File RZF-1996-116

Name: Redlands Water and Power – South Camp / South Broadway - Rezone

PUMPHOUSE SUBDIVISION

FILE: #RZF-96-116
DATE: May 29, 1996
STAFF: Kathy Portner
REQUEST: Rezone and Preliminary Plan, 3 lot Minor Subdivision
LOCATION: South Camp Road and South Broadway
APPLICANT: Redlands Water and Power

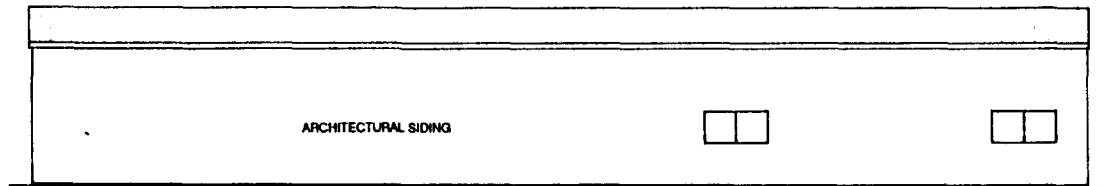
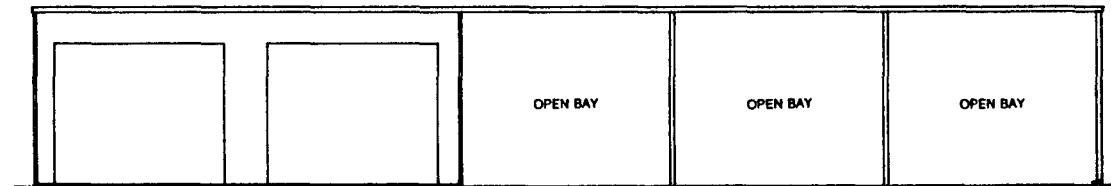
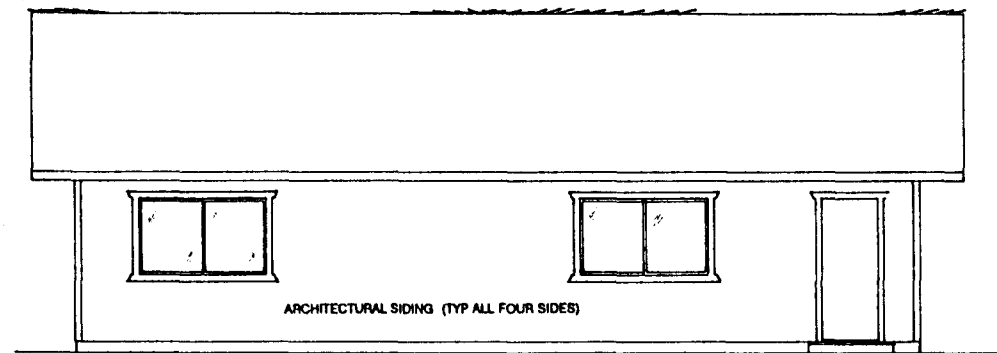
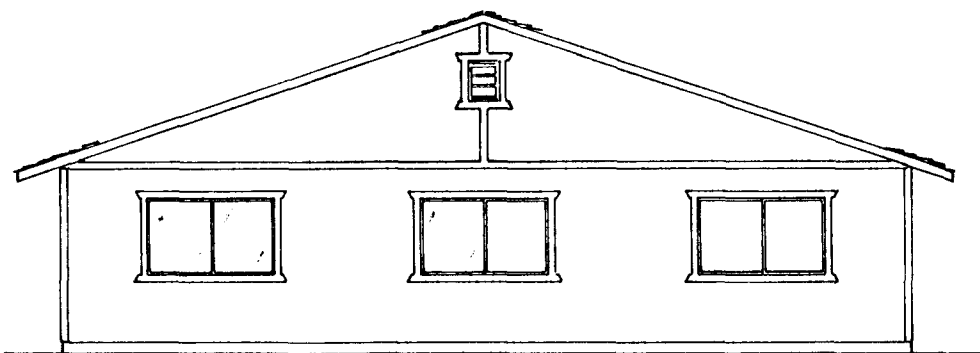
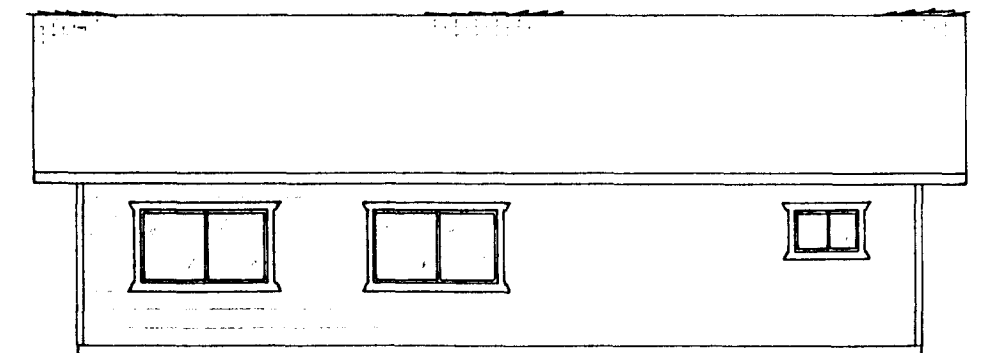
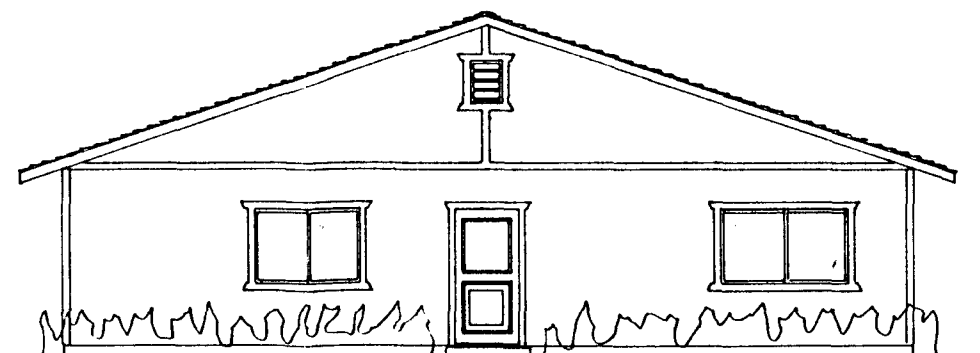
At their July 3, 1996 hearing, the City Council delayed a decision on the rezone and directed that the request be sent back to Planning Commission to review and approve the architectural design of the proposed structures. The design should be compatible with the surrounding residential area.

At their July 3, 1996 hearing, the City Council delayed a decision on the rezone and directed that the request be sent back to Planning Commission to review and approve the architectural design of the proposed structures. The design should be compatible with the surrounding residential area.

At their September 3, 1996 hearing, Planning Commission approved the proposed architectural design with the condition that earth-tone colors be required.

Staff recommends approval of the proposed design. Planning Commission will make a recommendation at their September 3, 1996 hearing.
